Executive Director's Recommendation

PROJECT Small Cell Infrastructure Guidelines Washington, DC	NCPC FILE NUMBER 7994
SUBMITTED BY District of Columbia Department of Transportation	NCPC MAP FILE NUMBER 00:00(41.22)44805
REVIEW AUTHORITY Review of Plans and Projects for Consistency with the Comprehensive Plan per 40 U.S.C. § 8711(e)(2)	APPLICANT'S REQUEST Approval of comments on draft guidelines
	PROPOSED ACTION Approve comments on draft guidelines
	ACTION ITEM TYPE Staff Presentation

Small Cell Infrastructure Guidelines

Approval of Comments on Draft Guidelines

VIEW 2: 10TH STREET

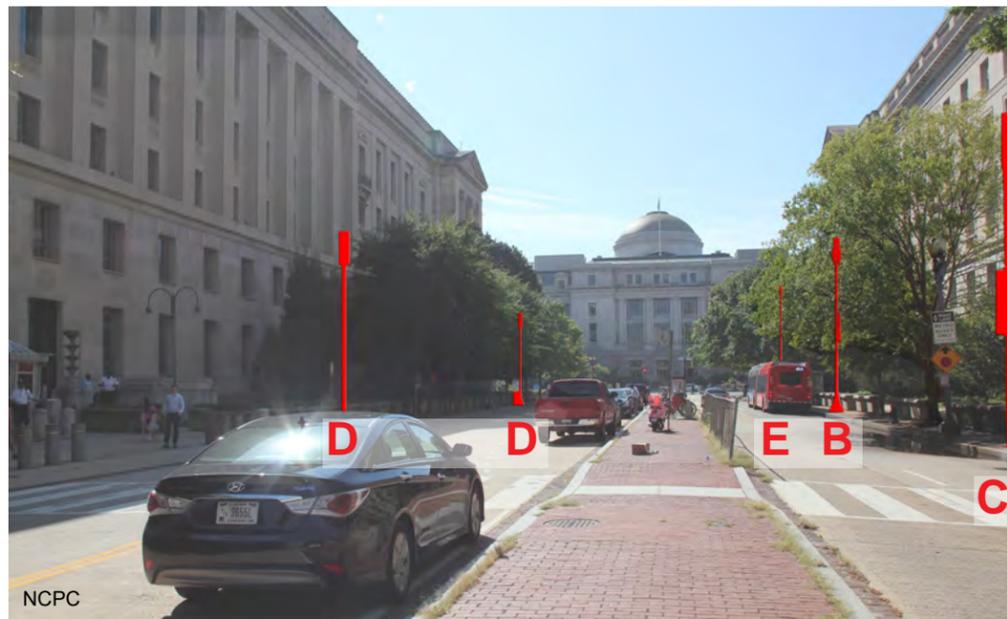
Seven standalone poles would be allowed on the block of 10th Street, NW between Constitution Avenue and Pennsylvania Avenue. The visualization shows the five poles that are furthest south toward the National Museum of Natural History.

VIEW 4: DEPARTMENT OF COMMERCE

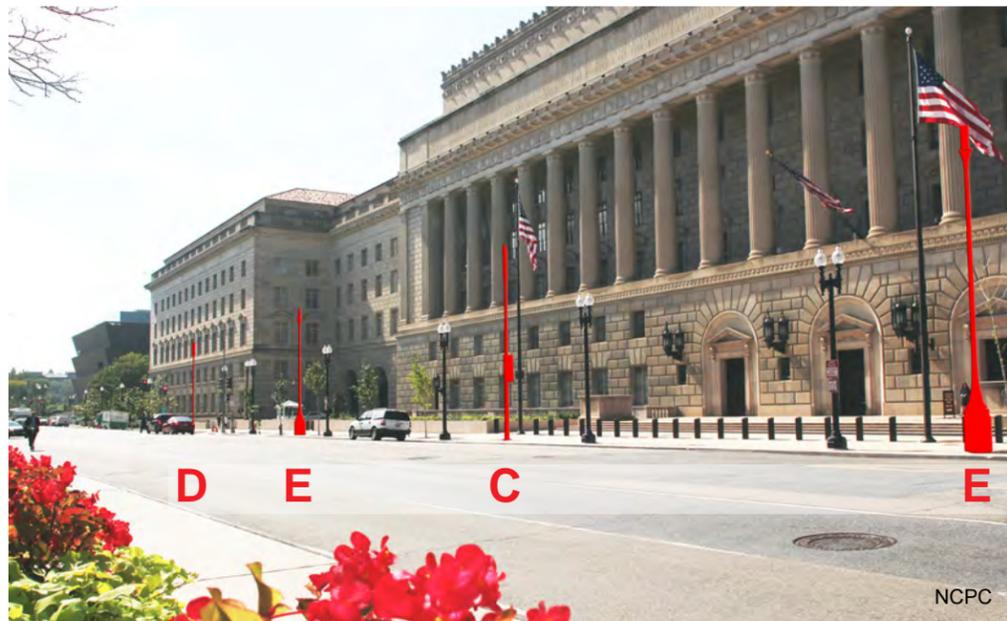
Five standalone poles would be allowed on the west side of 14th Street, NW, along the Department of Commerce Building. The visualization shows the four poles that are furthest south along the block. A fifth pole is located further north outside the view shown.

VIEW 8: F STREET

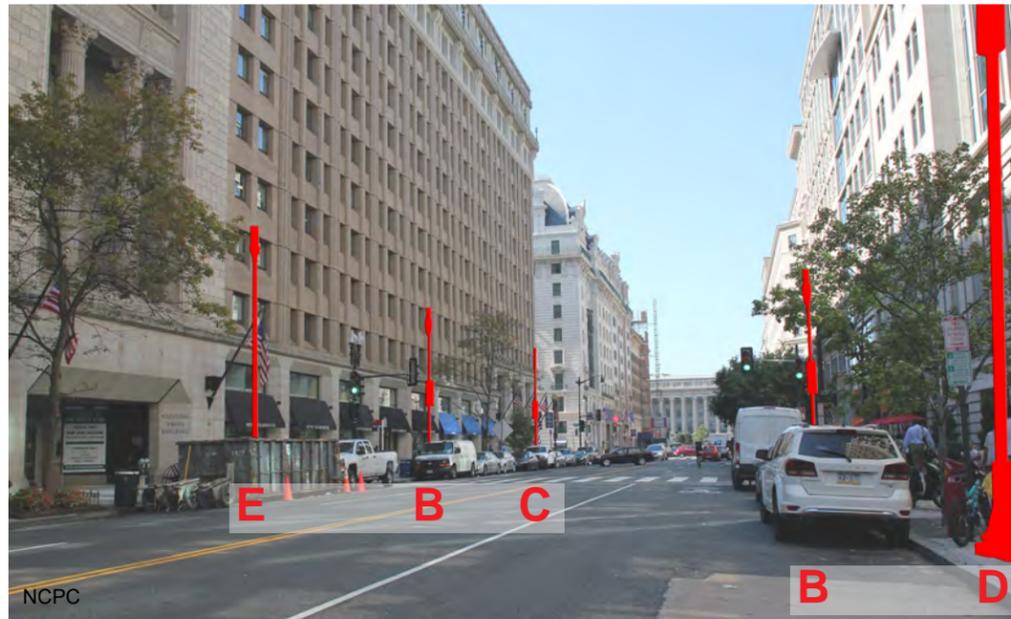
Six standalone poles would be allowed along F Street, NW between 13th and 14th Streets, NW. The visualization shows five of these poles, with three on the south side and two on the north side, looking toward the Treasury Building to the west. An additional pole is located outside of the view shown.
